**THE FUTURE
OF TRANSPORT**

R129 Non-Integral Internal Geometry Measurements

June 2016

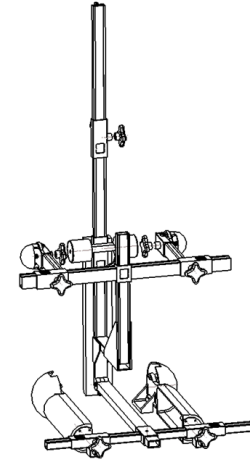
Why don't shoulder height requirements apply for non-integral ECRSs?

- The maximum shoulder height **should be** applied for **all** child restraints
- The reason is that this can occur:

- Sitting height ✓
- Hip width ✓
- Shoulder width ✓
- Shoulder height ✗

Result: Children do not fit

- Use existing device to measure shoulder height
- Shoulder height is measured using shoulder cylinders
- Cylinders aligned with lowest point of head pad

- 6.3.2.1. Internal geometric characteristics
- The Technical Service conducting the approval tests shall verify that the internal dimensions of the Child Restraint System conform to the requirements of Annex 18. The minimum dimensions for shoulder breadth, hip breadth and sitting height shall be fulfilled simultaneously for any stature within the size range declared by the manufacturer.
Integral Enhanced Child Restraint System shall also fulfil the minimum and maximum dimensions of shoulder height, for any stature within the size range declared by the manufacturer.
- **Non-integral Enhanced Child Restraint System shall also fulfil the maximum dimensions of shoulder height, for any stature within the size range declared by the manufacturer.**
